CITY PLANNING COMMISSION

B. Tentative Map - Riverbend Condos (P85-115)

C. Special Permit for a 14 unit condominium development (Sec 2-B-4)

D. Plan Review to develop 14 condominium units

TENTATIVE RIVERBEND CONDOMINIUMS

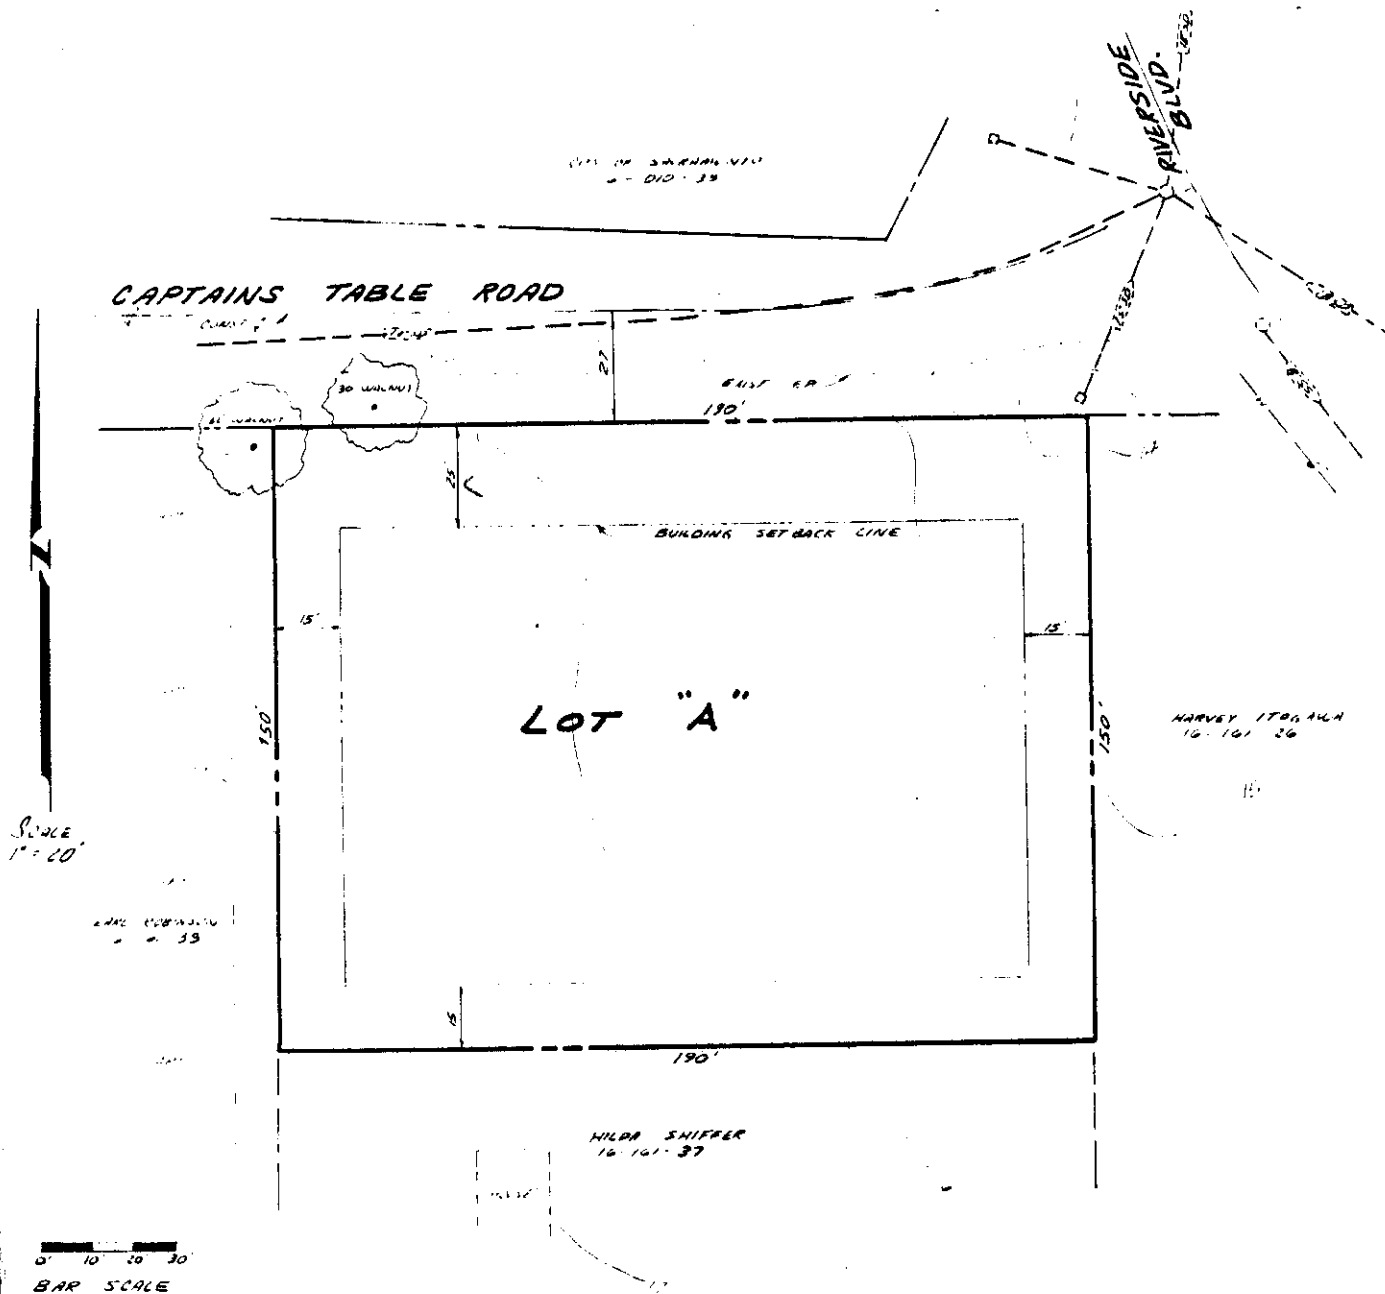
2. Site Design: The site plan indicates 25 foot wide parking aisles. The minimum requirement is 26 feet. This will necessitate a minor adjustment on the site plan.

EXHIBIT E

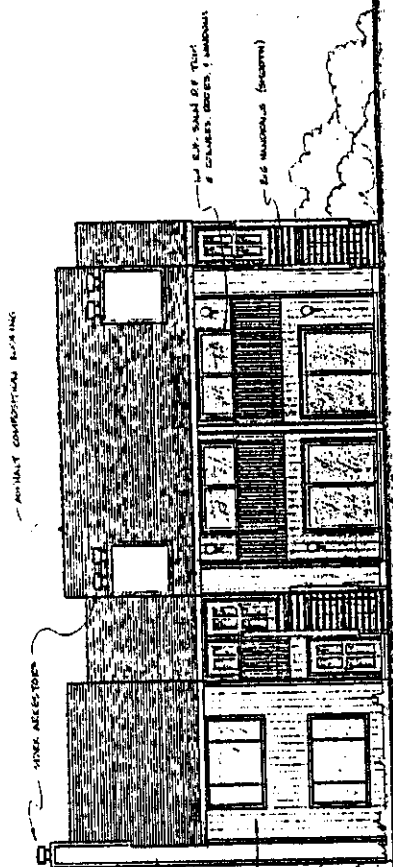
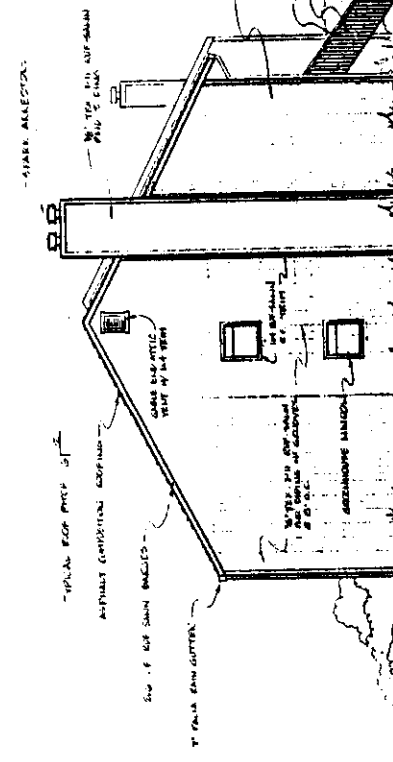
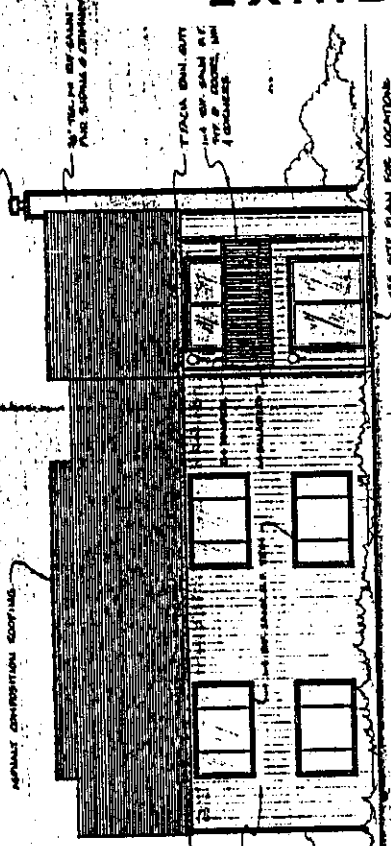
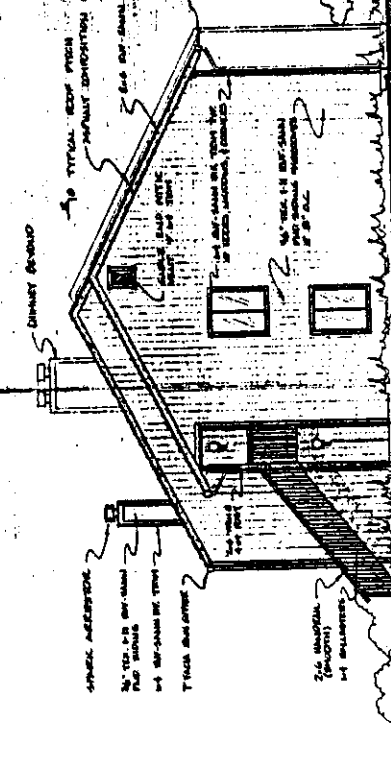
3. Building Design: To enhance the aesthetics of the project, staff suggests the following:
 - a. The submitted plans indicate straight-run stairways on the "B" models. Staff suggests these stairways be redesigned as an "L"-shaped stairway. The "L"-shape stairs will not protrude significantly into the open space areas. All stairways are to have stringers on each side.

- b. The submitted elevations indicate the roofing material as asphalt composition. Staff suggests that the roofing material be a medium wood shake or similar material and subject to the Planning Director's approval.

- c. Building materials should be a mixture of T-1-11 siding and stucco subject to the Planning Director's approval.
 - d. Private patio areas should have solid enclosures.

1. A detailed landscaping and irrigation plan which conforms to Exhibit G shall be submitted and approved prior to issuance of building permits.
2. The stairway to the second story Model B units shall be redesigned as an "L"-shaped stairway and be approved by the Planning Director.
3. Roofing materials shall be a medium wood shake or similar material and subject to Planning Director's approval.
4. Patios shall be enclosed with solid building material.
